ArgonCube 2x2 Installation Planning

ArgonCube 2x2 Installation Meeting on May 15, 2023

West Catwalk Cleanup for Safe Traffic (continued)

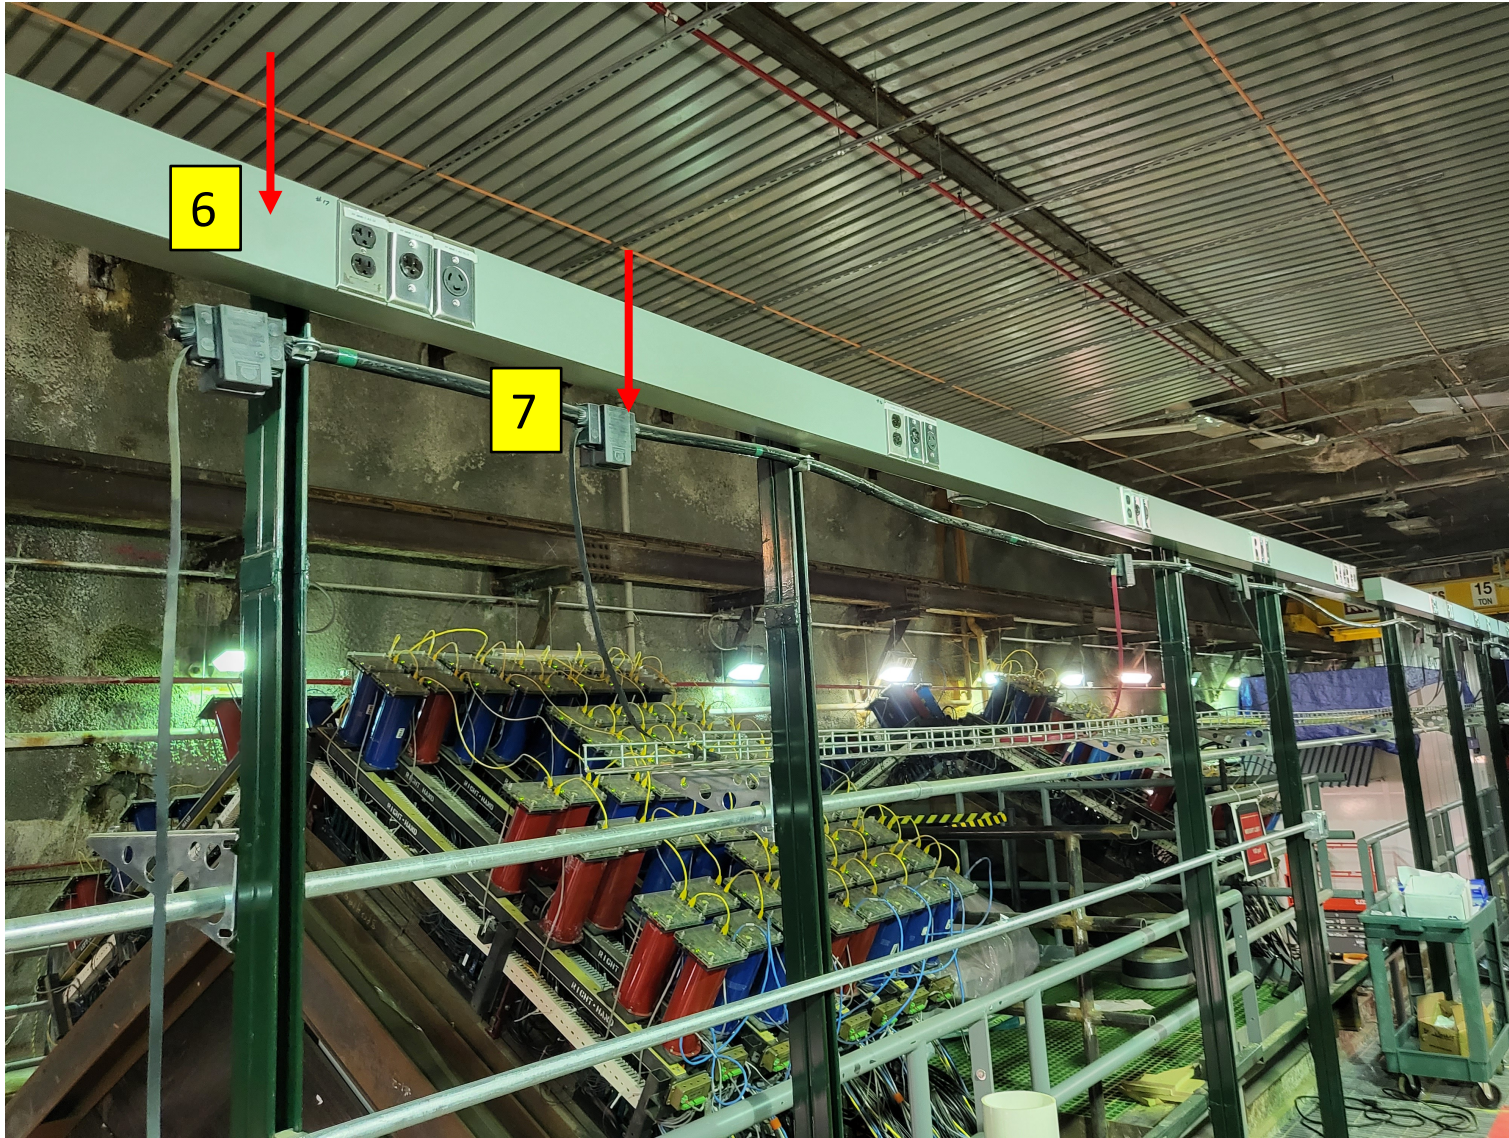
The Unistruts 4 and 5 can be arranged to be removed.

Delaying decision to remove until we decide how to extend the floor in order to support a MINERvA detector electronics maintenance.

West Catwalk Cleanup for Safe Traffic (continued)

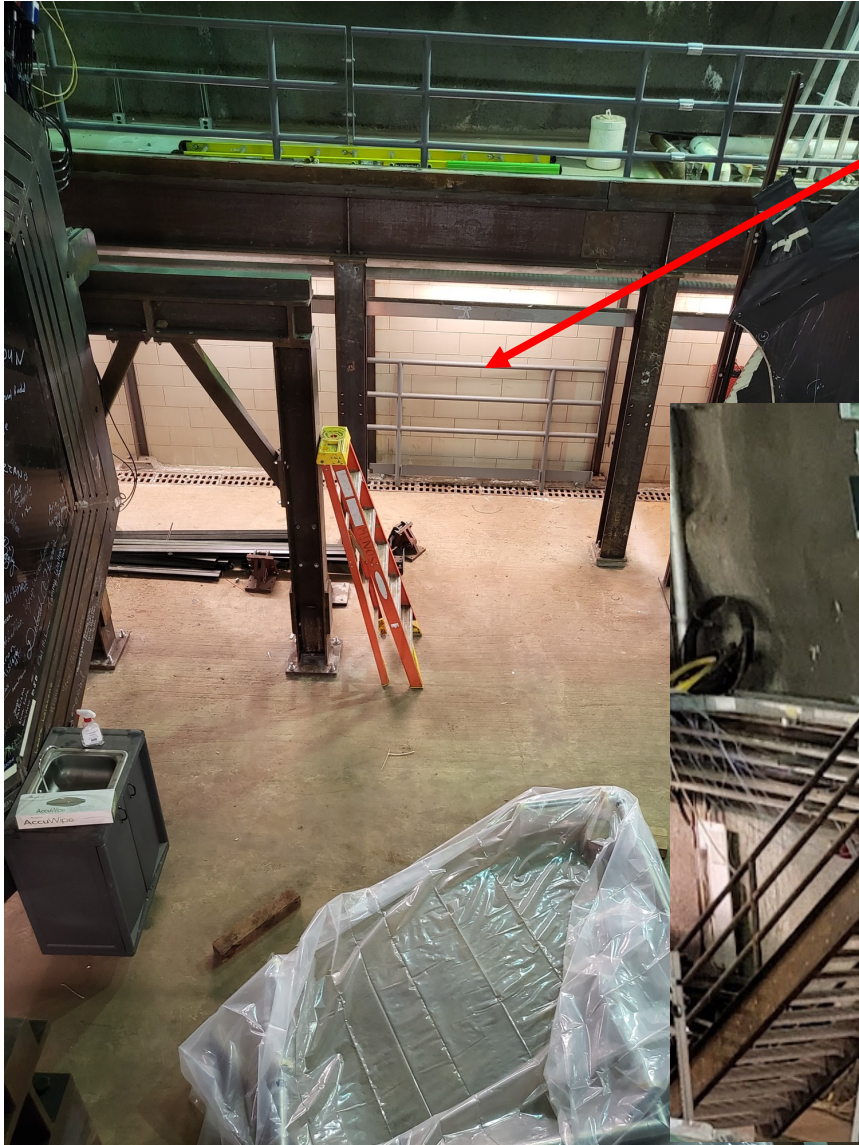
Wireway 6 and 7 will stay. We need them as per Matt Micheli.

West Catwalk Cleanup for Safe Traffic (continued)

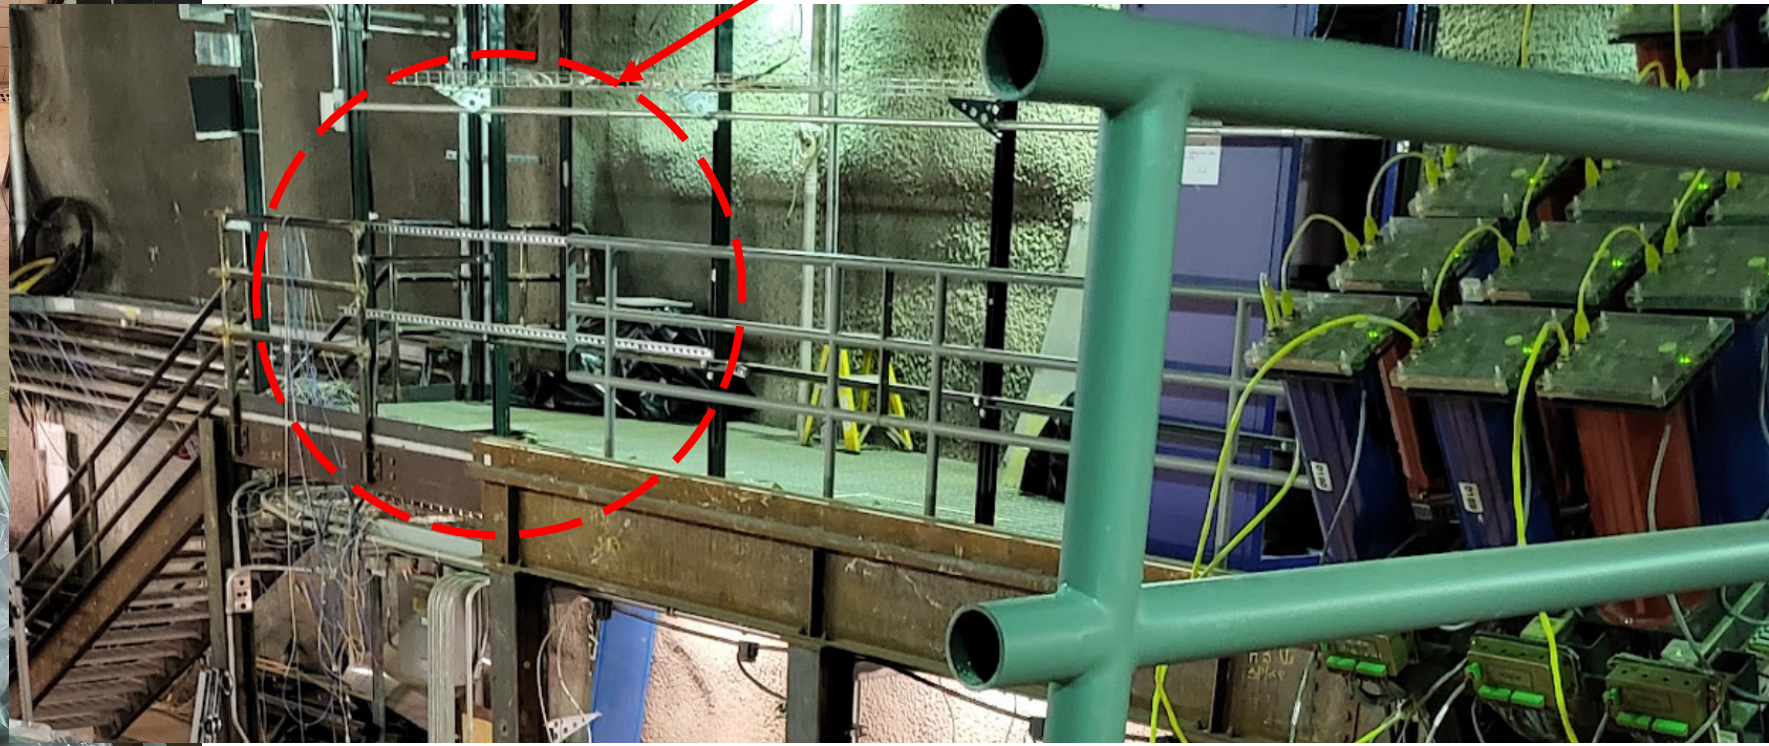
Question to Steve: Is this reserved for something?
